**SUSQUEHANNA STEAM ELECTRIC STATION  
REQUESTS FOR ADDITIONAL INFORMATION (RAI) FOR THE  
REVIEW OF THE SUSQUEHANNA STEAM ELECTRIC STATION,  
UNITS 1 AND 2 LICENSE RENEWAL APPLICATION (LRA)  
SECTIONS 2.2 AND 2.3  
PLA-6257**

**Docket Nos. 50-387  
and 50-388**

**Enclosure to PLA-6257  
PPL Responses to NRC's  
Request for Additional Information (RAI)**

**Revised Boundary Drawing LR-M-157 Sheet 4**

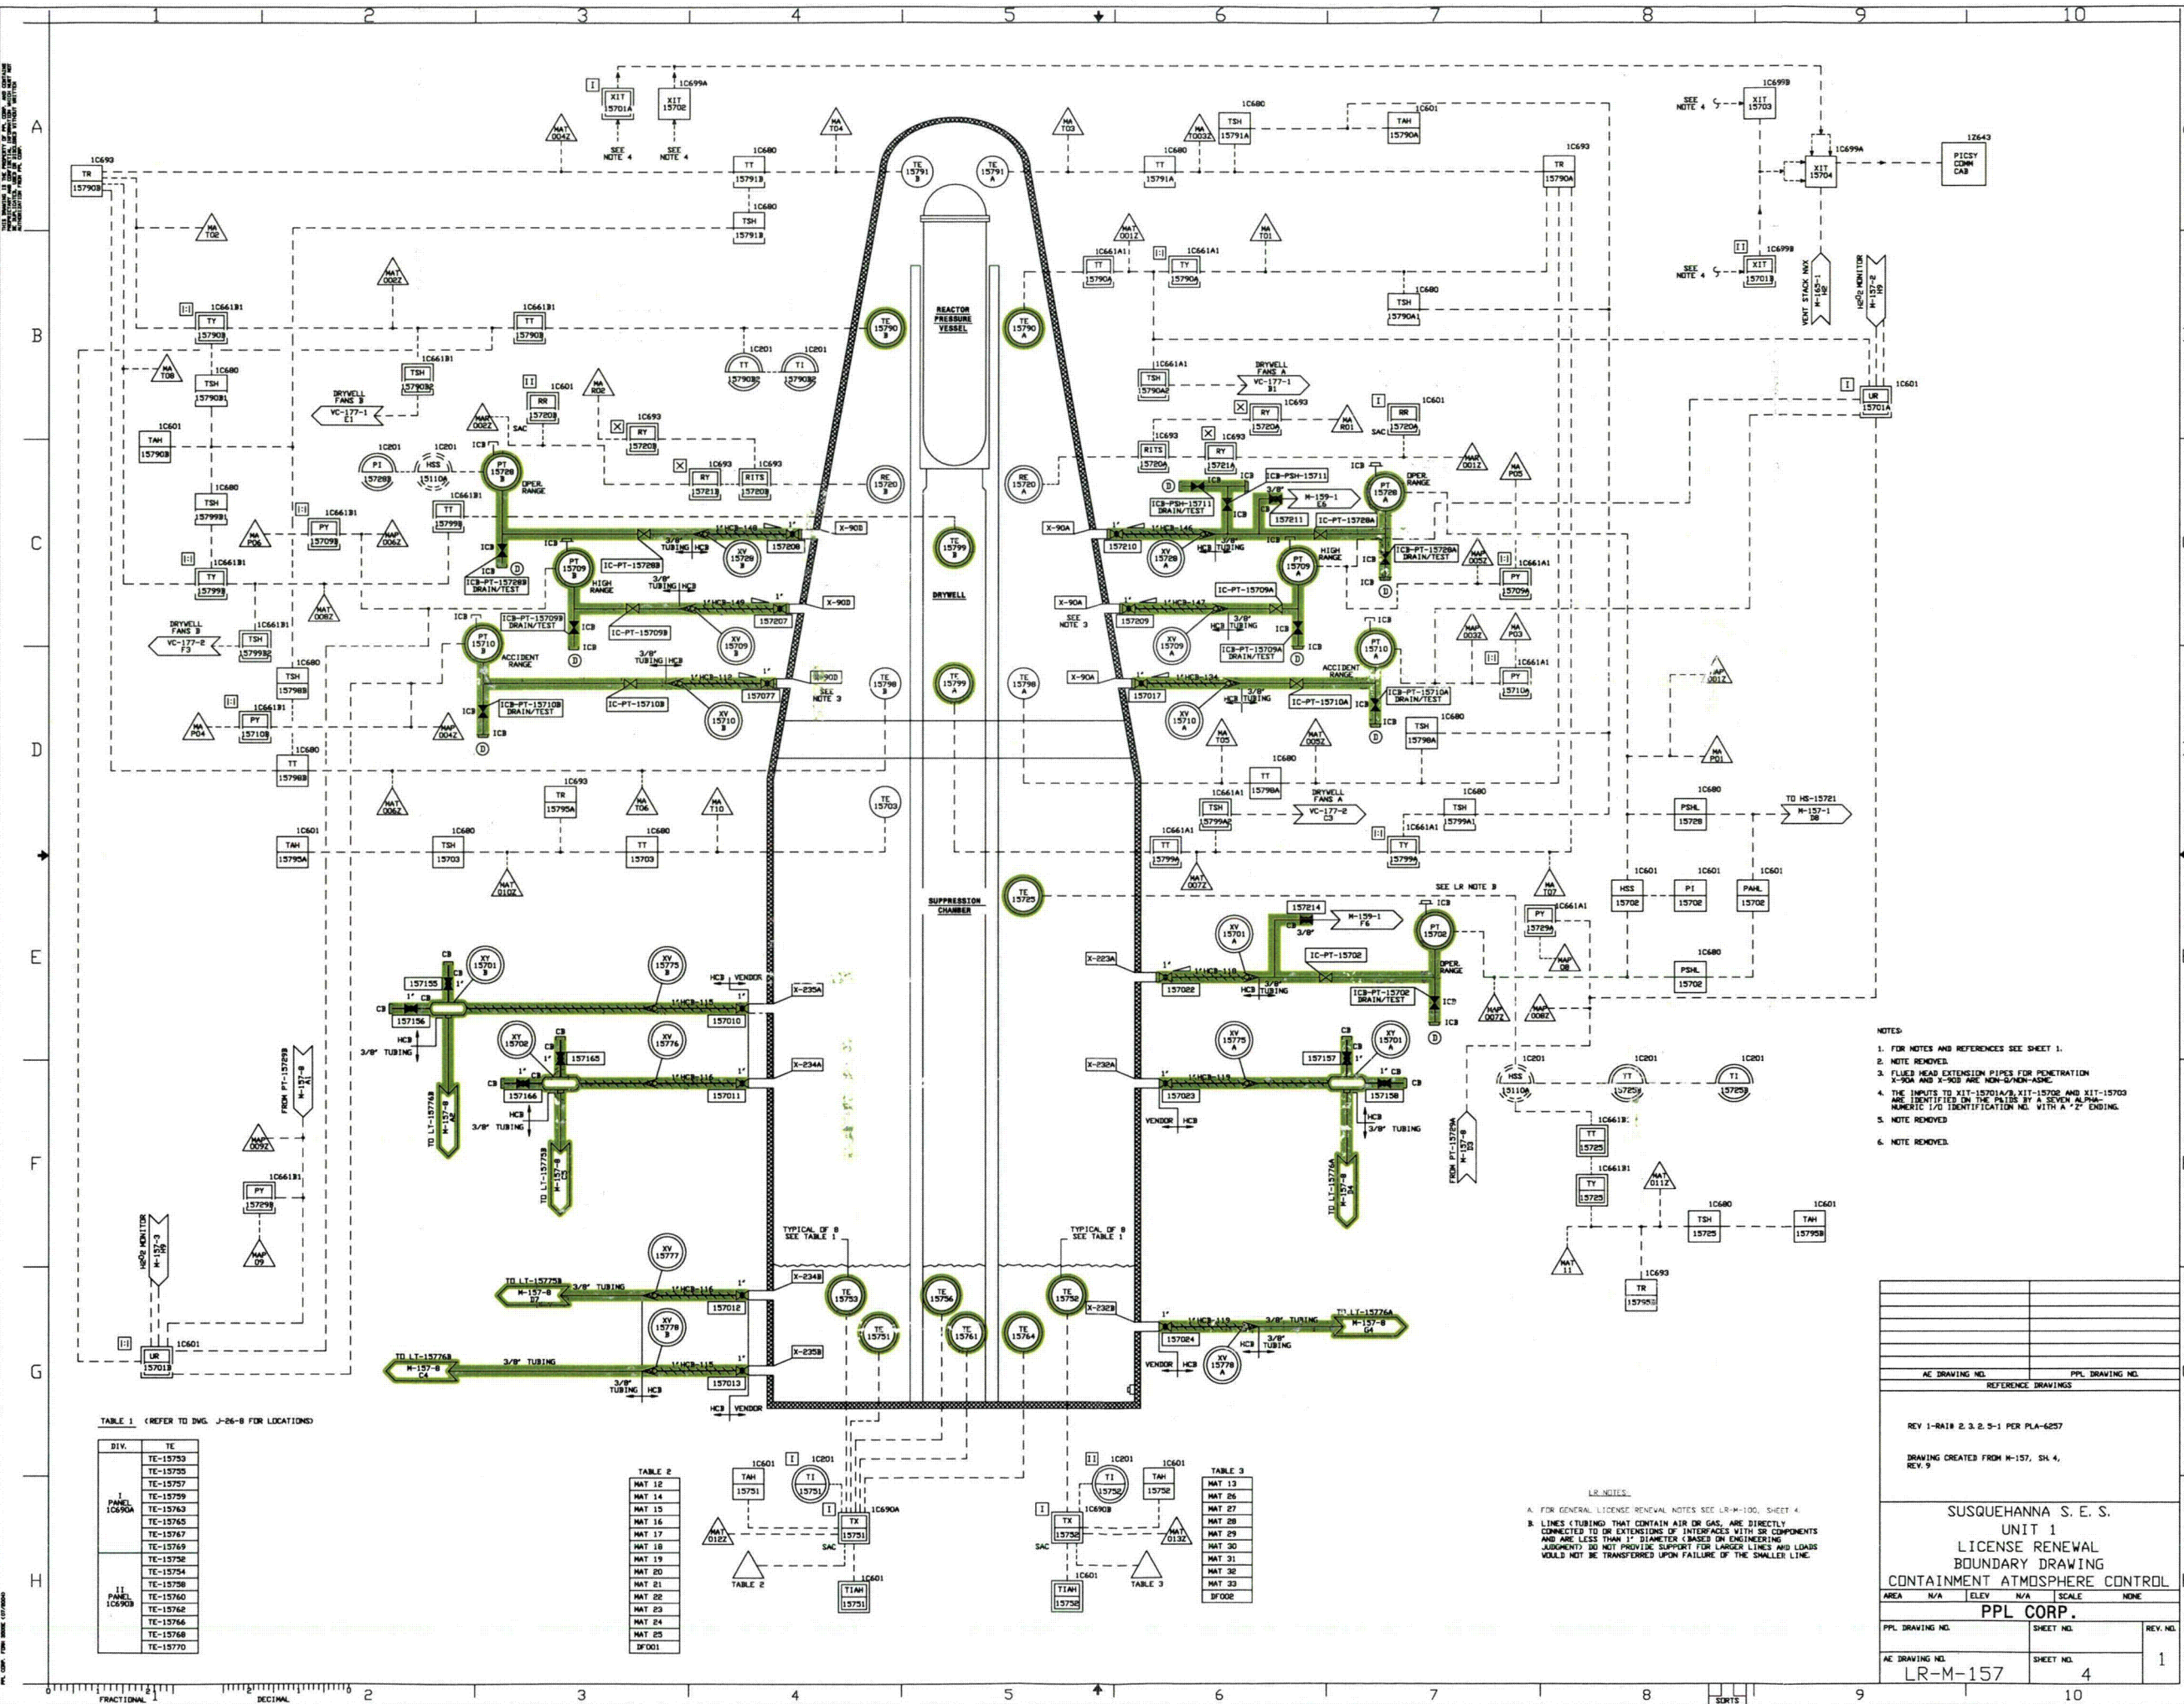
Drawing No. LR-M-157, Sheet 4, 1-inch valve 157011 at penetration X-234A and 1-inch valve 157023 at penetration X-232A which belong to suppression pool level monitoring system are shown as not in scope for license renewal.

Provide justification for the exclusion of these valves from the scope of license renewal. If these valves are in the scope of license renewal, in accordance with 10 CFR 54.4(a), and subject to an aging management review in accordance with 10 CFR 54.21(a)(1), update the LRA by providing the applicable information in the appropriate LRA Sections, tables, and drawings.

Boundary drawing LR-M-157 sheet 4 contained an error related to highlighting. Valve 157011 at penetration X-234A and valve 157023 at penetration X-232A are both in-scope and subject to aging management review, but they were inadvertently not highlighted. Both valves have been highlighted in green on the revised boundary drawing LR-M-157 sheet 4, included as Attachment 1.

In the course of addressing this RAI, it was also noticed that the highlighting at penetration X-90D for 1-inch line HCB-112 was slightly different from the highlighting for the other pipelines at penetrations X-90A and X-90D. The short length of piping between valve 157077 and the penetration should have been highlighted. This piping is in-scope and subject to aging management review, but was inadvertently not highlighted. This piping has been highlighted in green on the revised boundary drawing LR-M-157 sheet 4, included as Attachment 1.

**Revised Boundary Drawing LR-M-157 Sheet 1**

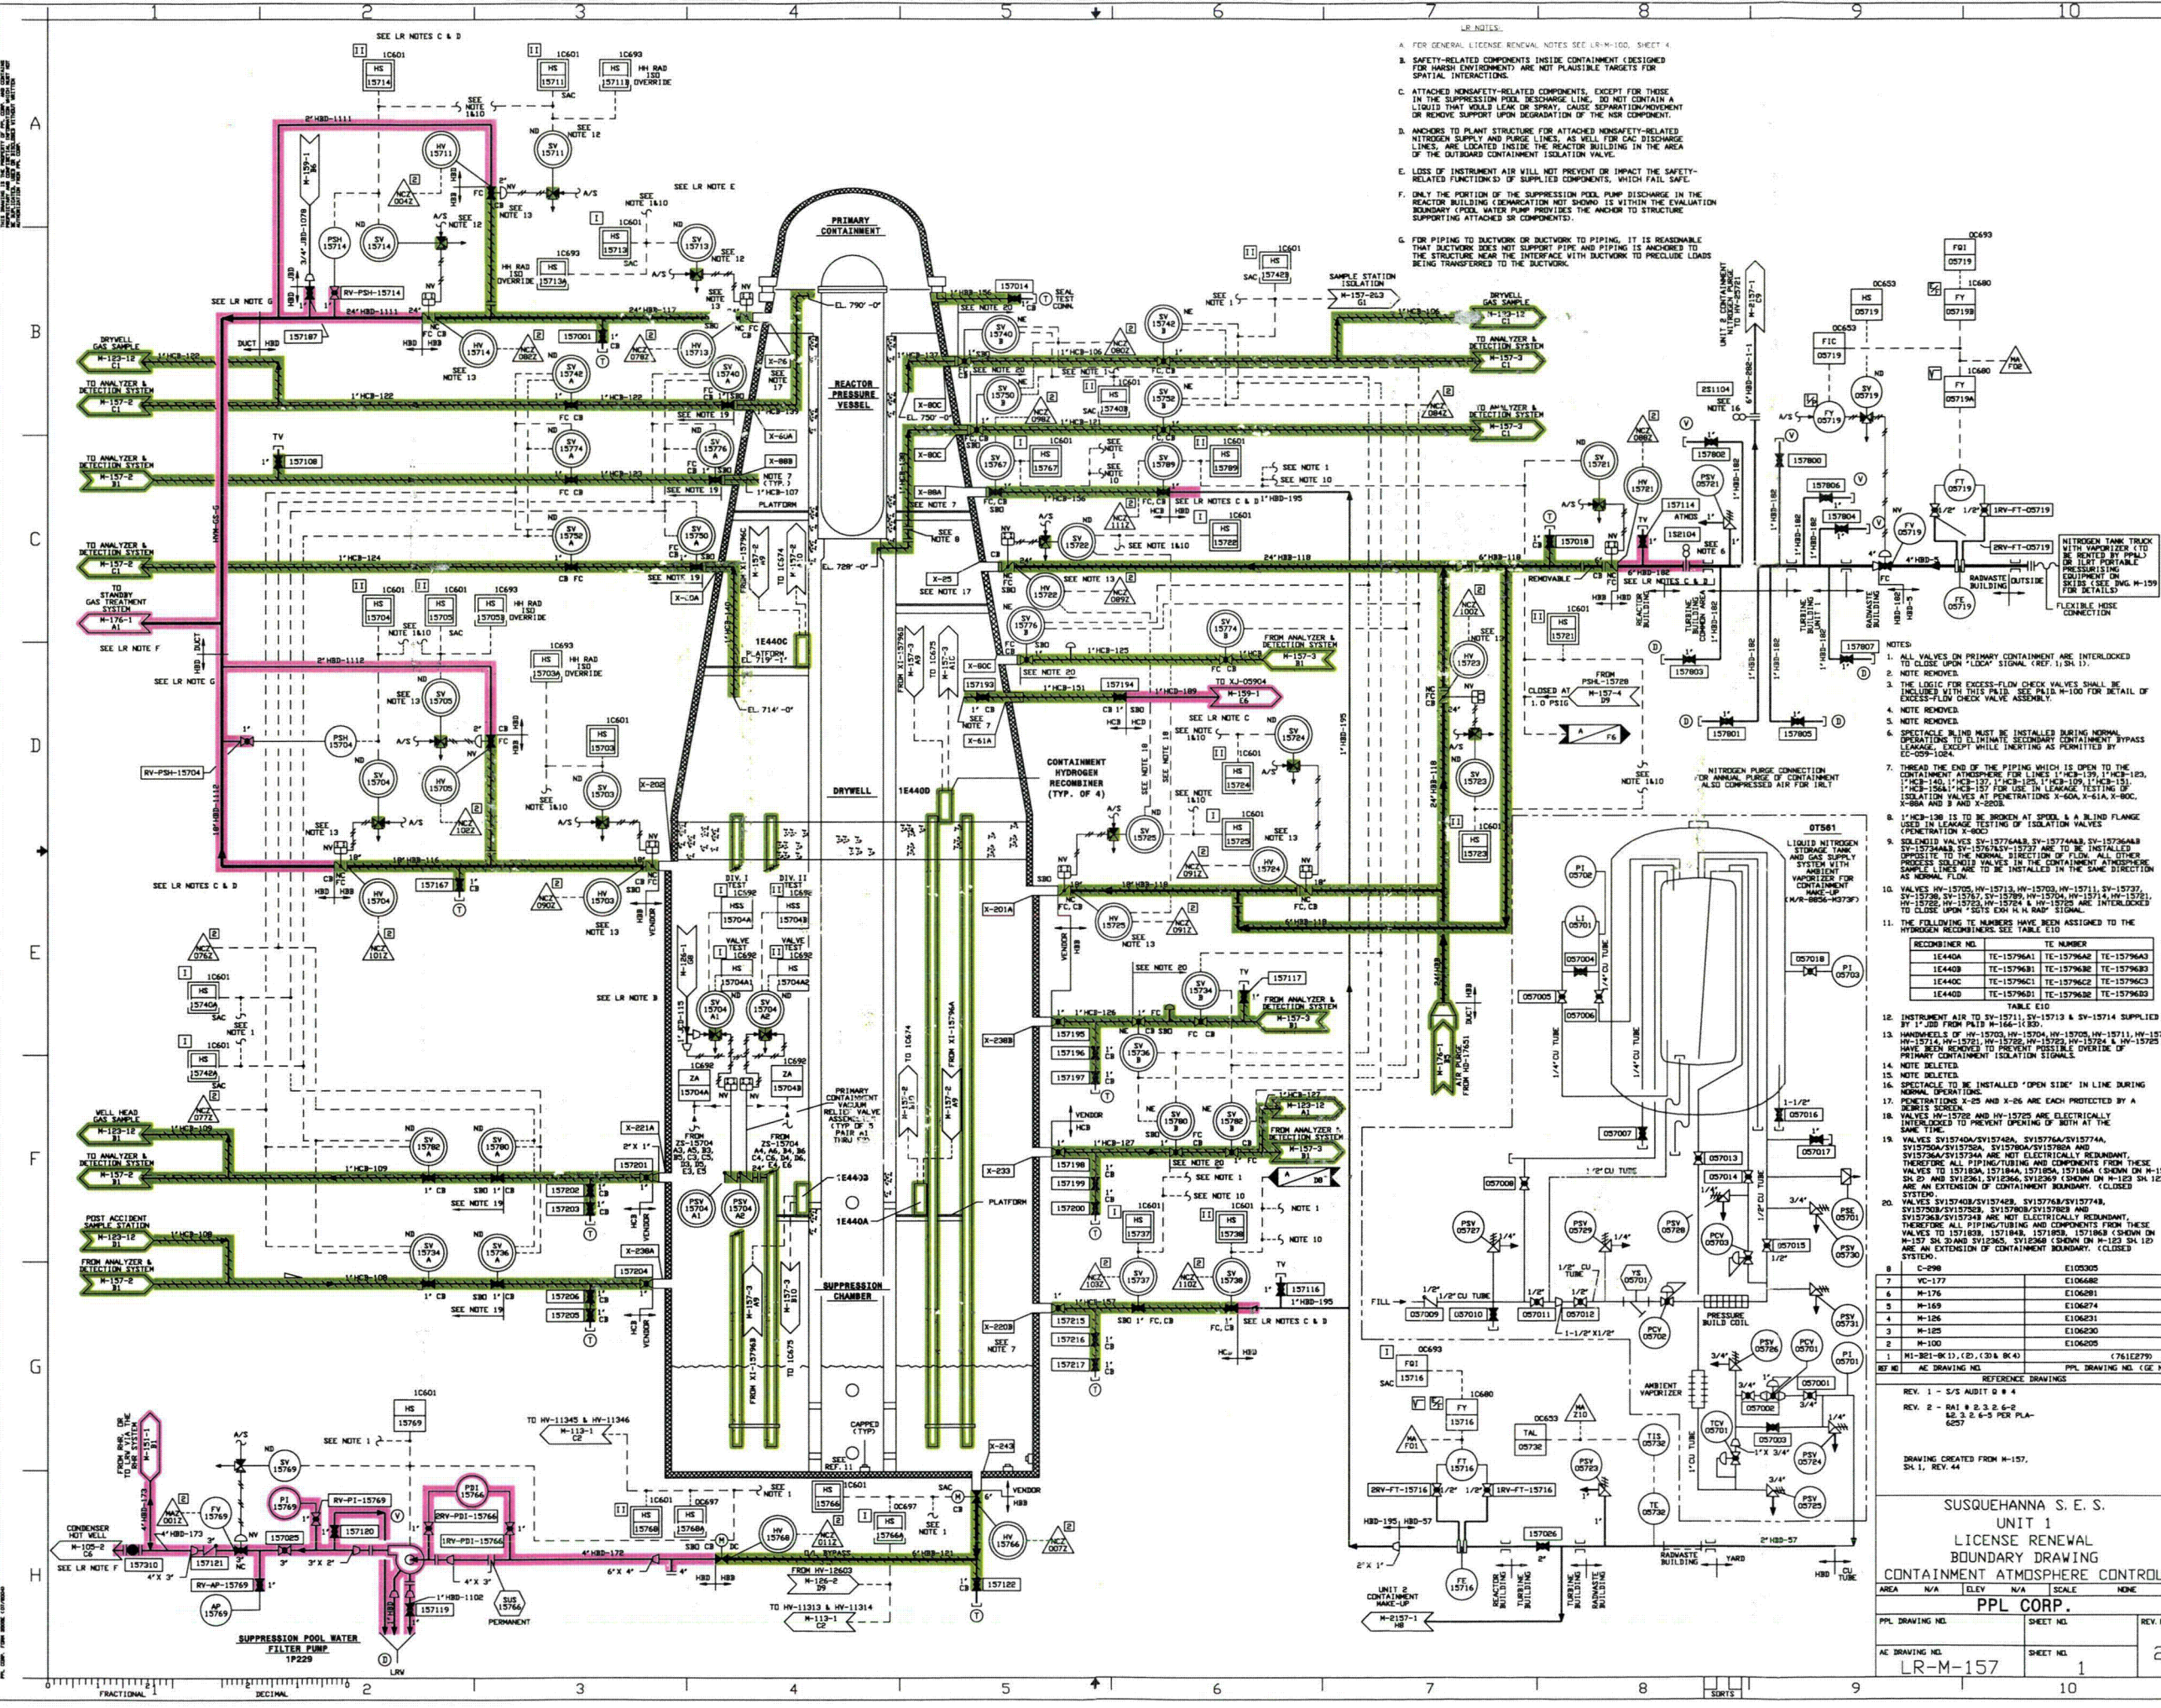
FSAR Table 6.2-12, "Containment Penetration Data" shows the 24-inch butterfly valve HV15722 as a containment isolation safety-related valve located at drywell penetration X-25. This valve located in zone C-5 of drawing No. LR-M-157 Sheet No. 1 is shown as not in scope of license renewal.

Provide justification for the exclusion of this valve from the scope of license renewal. If this valve is in the scope of license renewal, in accordance with 10 CFR 54.4(a), and subject to an aging management review in accordance with 10 CFR 54.21(a)(1), update the LRA by providing the applicable information in the appropriate LRA Sections, tables, and drawings.

Drawing LR-M-157, sheet 1, zone F-3, at primary containment penetration X-221A shows the piping component at the upstream side of valve 157201 as not in scope for license renewal.

Provide justification for the exclusion of this piping component from the scope of license renewal. If this component is in the scope of license renewal, in accordance with 10 CFR 54.4(a), and subject to an aging management review in accordance with 10 CFR 54.21(a)(1), update the LRA by providing the applicable information in the appropriate LRA Sections, tables, and drawings.

Boundary drawing LR-M-157 sheet 1 contained an error related to highlighting. Valve 157022 and the short length of piping between the valve and penetration X-25 are in-scope and subject to aging management review, but they were inadvertently not highlighted. The valve and the piping have been highlighted in green on the revised boundary drawing LR-M-157 sheet 1, included as Attachment 4.

Boundary drawing LR-M-157 sheet 1 contained an error related to highlighting. Valve 157201 at penetration X-221A has a 2-inch by 1-inch reducer that is in-scope and subject to aging management review, but it was inadvertently not highlighted. The reducer has been highlighted in green on the revised boundary drawing LR-M-157 sheet 1, included as Attachment 4.
